SUBJECT: Application for amends to licenses DPR-58 & DPR-74, revising
 TS 3/4.6.2, "RCS Operational Leakage" by deleting Table
 3.4-0, "RCS Pressure Isolation Valves," LCO 3.4.6.2f &
 Action c & SRs 4.4.6.2.2 for both units.

AEP:NRC:1180

Donald C. Cook Nuclear Plant Units 1 and 2
Docket Nos. 50-315 and 50-316
License Nos. DPR-58 and DPR-74
TECHNICAL SPECIFICATION CHANGE REQUEST
REACTOR COOLANT SYSTEM PRESSURE ISOLATION VALVES

FIGURE 11

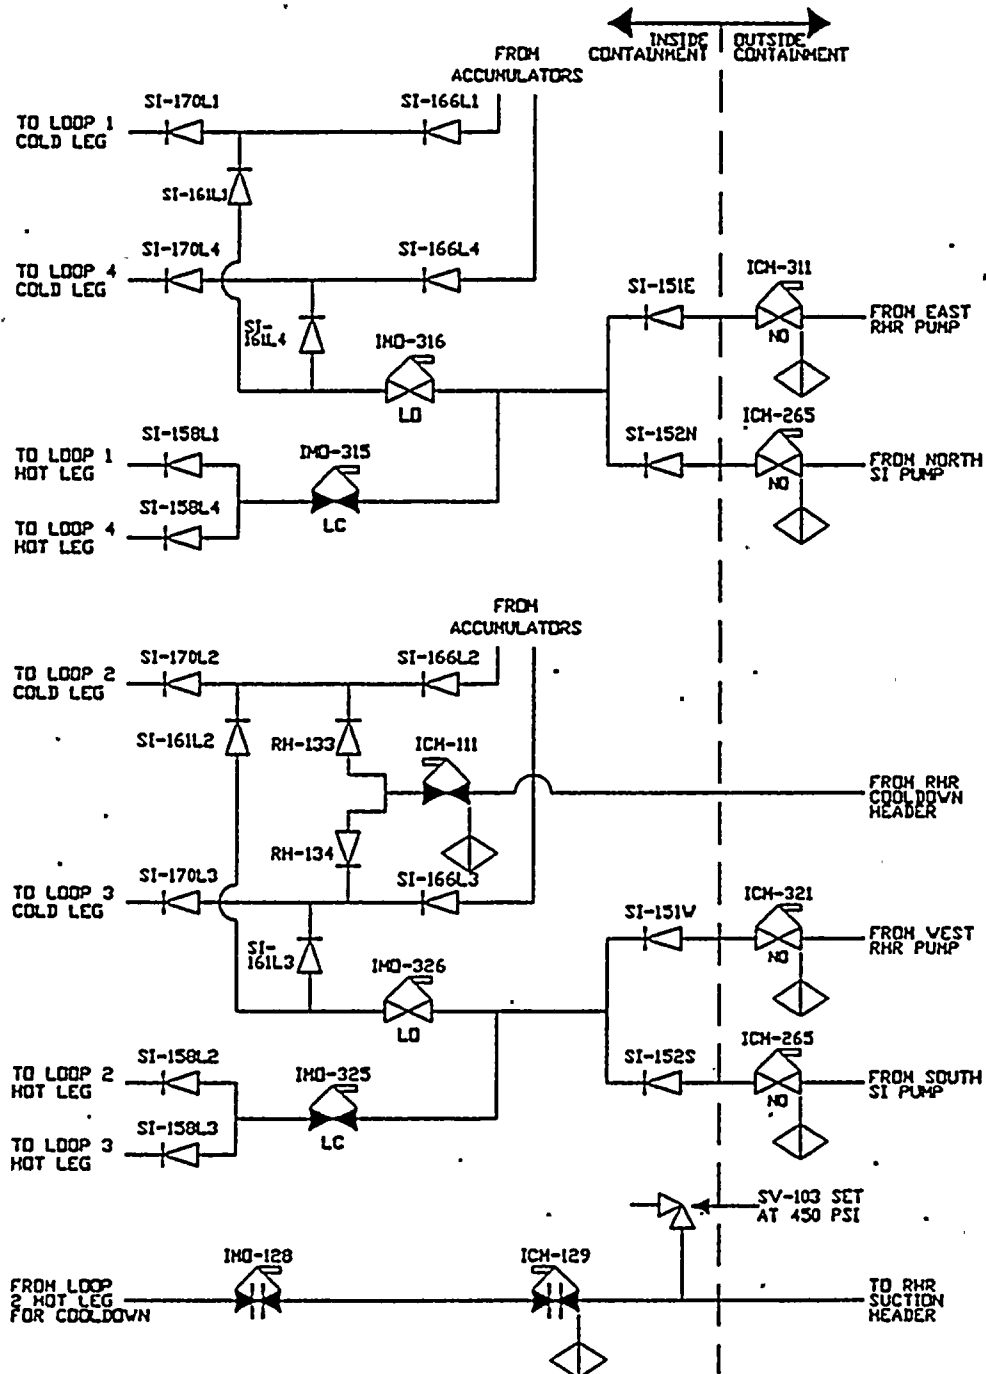
In the Cook Nuclear Plant IPE, nine different pathways for an ISLOCA event were analyzed. These pathways (see Enclosure to this Attachment), consisted of either three check valves in series, two check valves and a closed motor operated valve (MOV) in series, or two normally closed MOVs in series. Although WASH-1400 looked at check valve leak testing as a sensitivity analysis, the Cook Nuclear Plant IPE accounted for the in-place leak testing when calculating the probability of an ISLOCA occurring. In addition, the Cook Nuclear Plant IPE modeled mitigating actions for the ISLOCA event in the event tree. The

DONALD C. COOK NUCLEAR PLANT PATHS CONSIDERED AS POSSIBLE V-SEQUENCE LOCAS
